<b>Docket Number:</b>	15-IEPR-12
<b>Project Title:</b>	Nuclear Power Plants
<b>TN #:</b>	204602-13
<b>Document Title:</b>	Attachment 13
<b>Description:</b>	N/A
<b>Filer:</b>	Sabrina Savala
<b>Organization:</b>	Pacific Gas & Electric Company
<b>Submitter Role:</b>	Public Agency
<b>Submission Date:</b>	5/12/2015 12:37:04 PM
<b>Docketed Date:</b>	5/12/2015

# Attachment 13

Re: Pacific Gas and Electric Company's Response to CPUC Independent Peer Review Panel Report Nos. 7, 8, and 9

**Figure 1. Tornado Plot summarizing seismic hazard parameters and the impact of parameter uncertainty on the total hazard uncertainty. Parameters whose uncertainties contribute more to total hazard uncertainty are shown at the top of the plot.**

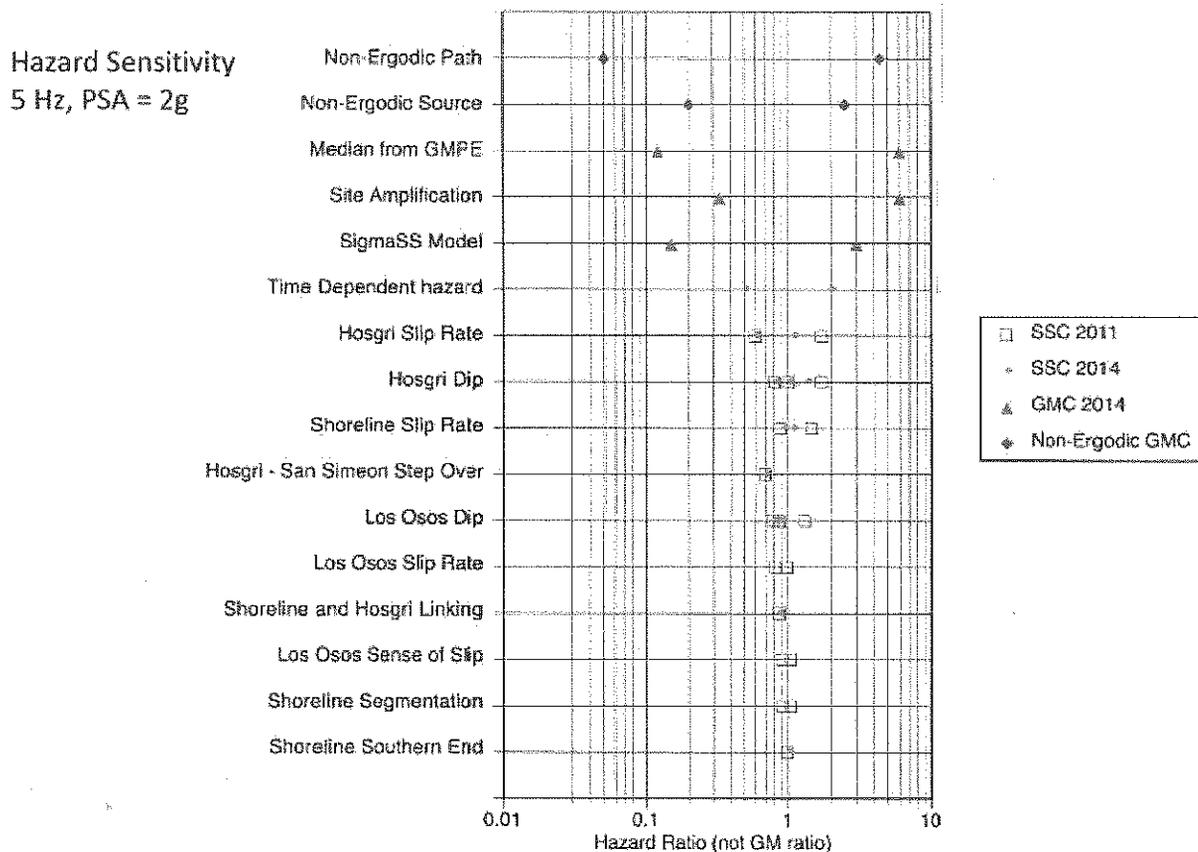
IPRP Report No. 7 suggested areas for additional research, particularly to develop better constraints on age estimates of offset features mapped by the LESS, with an emphasis on the offsets of younger (<20 ka) rather than older offset features. Collecting data to improve the age dates and/or identify additional, younger offset features in the offshore region is a major task. As shown by the tornado plot on Figure 1 below (which is equivalent to Figure 4 of IPRP Report No. 9), the current uncertainties in the Hosgri and Shoreline slip rates, which incorporate large age uncertainties, lead to less uncertainty in the total seismic hazard than the current uncertainties in the rock ground motion models and site amplification models. Therefore, the collection of data to improve the age dates and/or resolution of offset features along the Hosgri or Shoreline fault will likely be a lower priority. The final prioritization of any additional studies to reduce the uncertainty in the hazard will be developed as part of PG&E's ongoing Long Term Seismic Program (LTSP).

The currently available broadband data from small earthquakes does not provide improved constraints on the DCCP site terms because the station coverage is too sparse. Improved source, path, and site response terms are part of a separate longer term study being planned with the Southern California Earthquake Center. This project plan will be developed as part of the overall effort to reduce the uncertainty in the seismic hazard as presented in Figure 1.
